CITY OF NOVI CITY COUNCIL
AUGUST 8, 2022

SUBJECT: Approval of (1) the request of Sakura Novi Land Development LLC for JSP 22-09 Sakura Novi for Preliminary Site Plan with Site Condominium, Phasing Plan, Wetland Permit, Woodland Permit, and Storm Water Management Plan, and (2) First Addendum to the PRO Agreement. The subject property is zoned TC-1 with a Planned Rezoning Overlay (PRO), which conditions development to the terms of a PRO Plan and Agreement. The site is approximately 15 acres in size and is located north of Grand River Avenue, south of Eleven Mile Road, and east of Town Center Drive (Section 23). The applicant is proposing to develop a mixed-use development including commercial retail, office, and restaurant uses, and multifamily residential units.

SAKURA NOVI: JSP22-09

TYPICAL UNIT B DETAIL
SCALE: 1" = 30'-0"

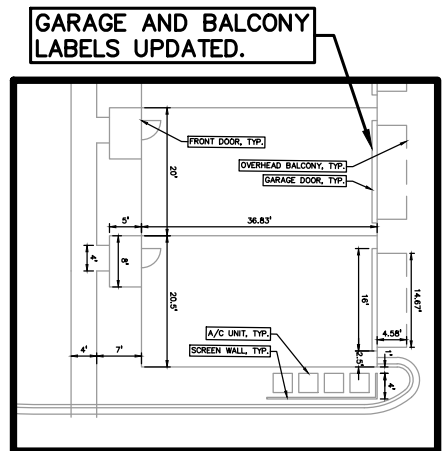
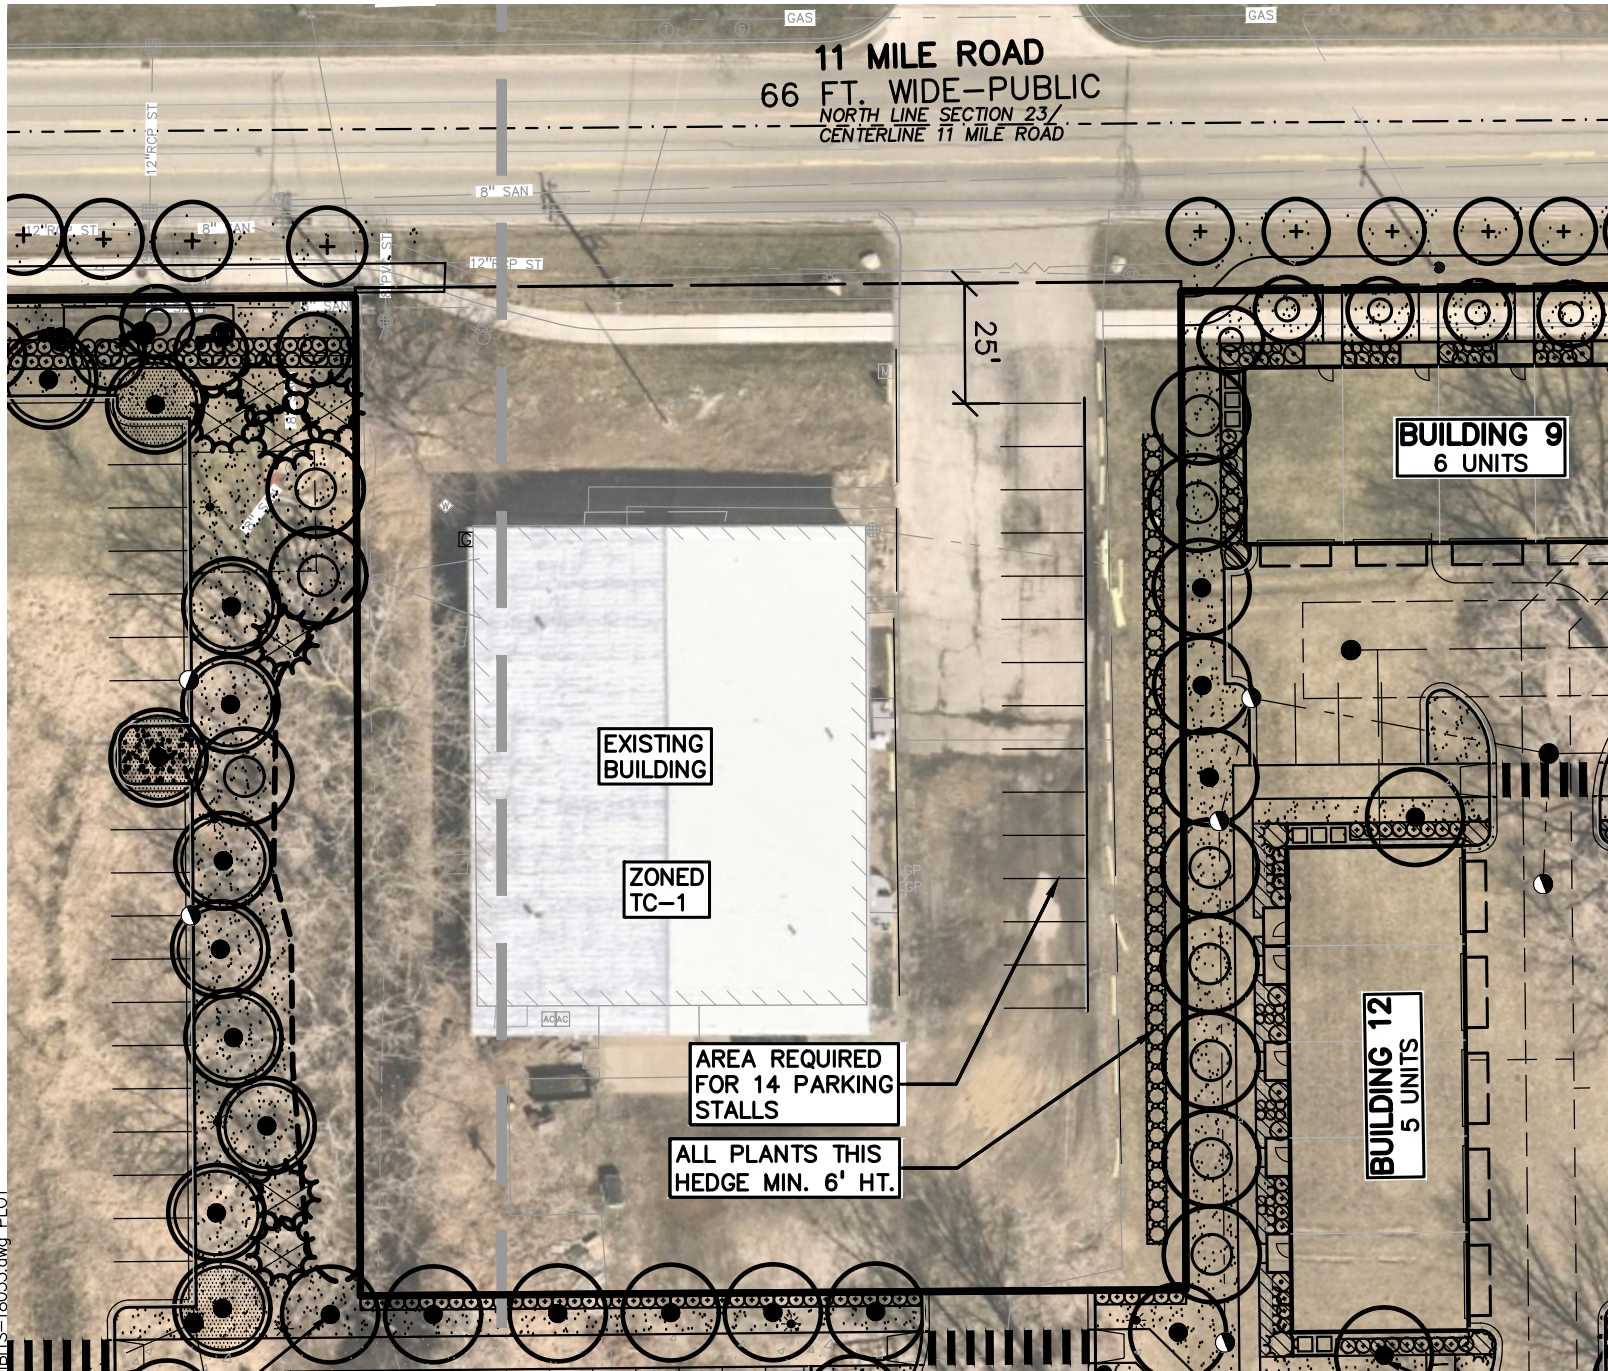
- g. Barrier-free signage is required for the ADA spaces west of Building 19 (Sheet C-2.2).
- h. "Typical Unit B Detail" – Balcony and Garage Door labels appear to be pointing to incorrect locations (Sheet C-2.2).

See **Attachment Sheet 5** for the notations added as requested.

SHEET 9

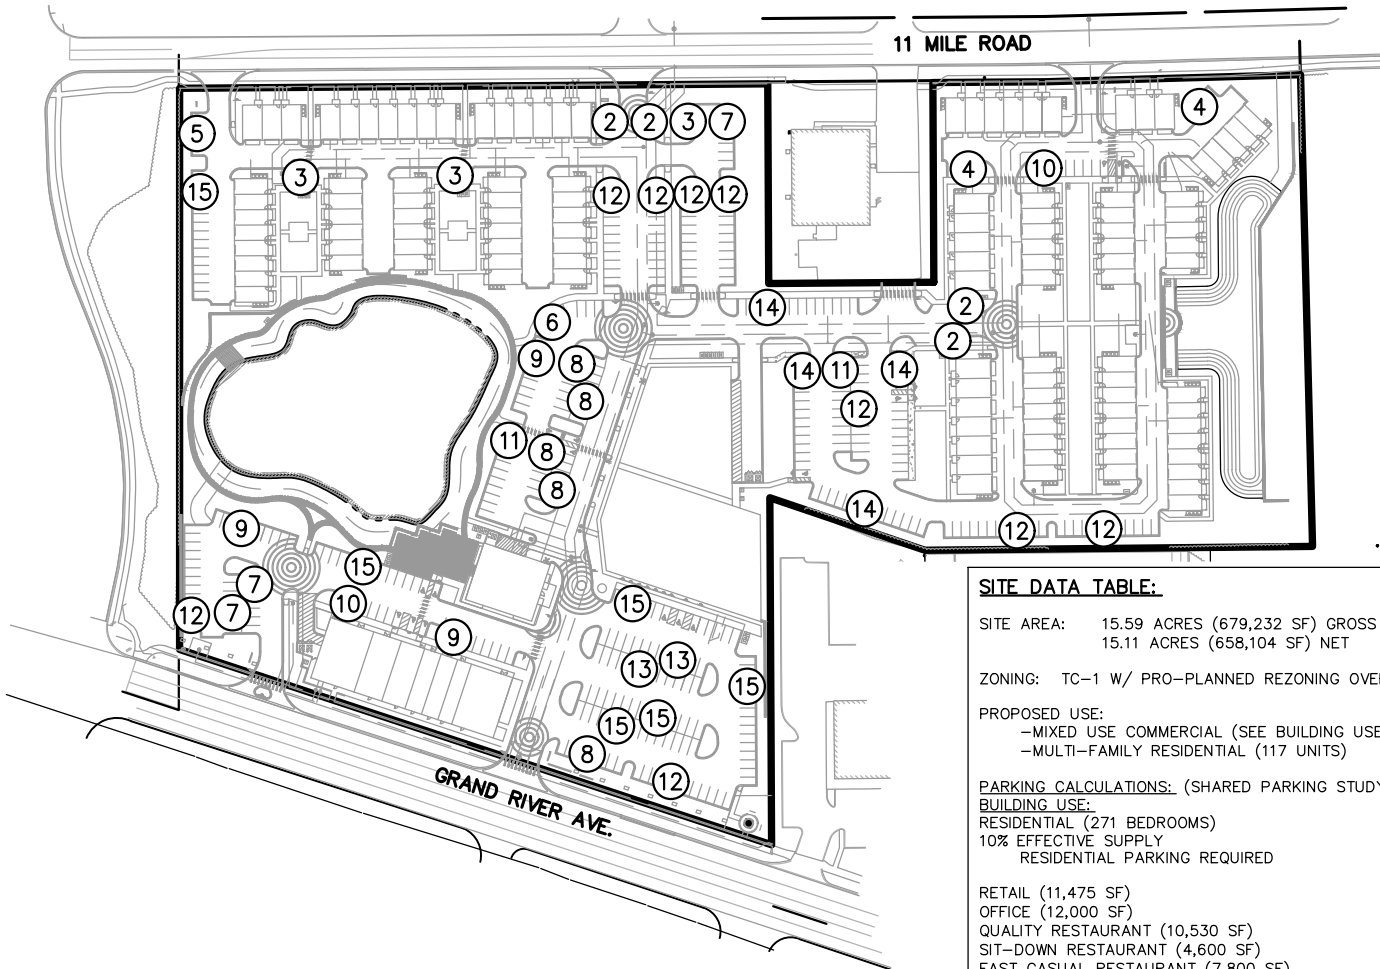
Sheet C-2.0 indicates 92 parking spaces in Phase 2 – unclear where those are located

This parking chart correction will be made at the time of Final Site Plan submission. The parking study uses all correct parking quantities as shown on site for the Phase 1 analysis. Corrected Parking Chart included as **Attachment Sheet 9**.

See **Attachment Sheet 9** for the notation to add the requested signs.

See **Attachment Sheet 9** for the bicycle parking schedule.
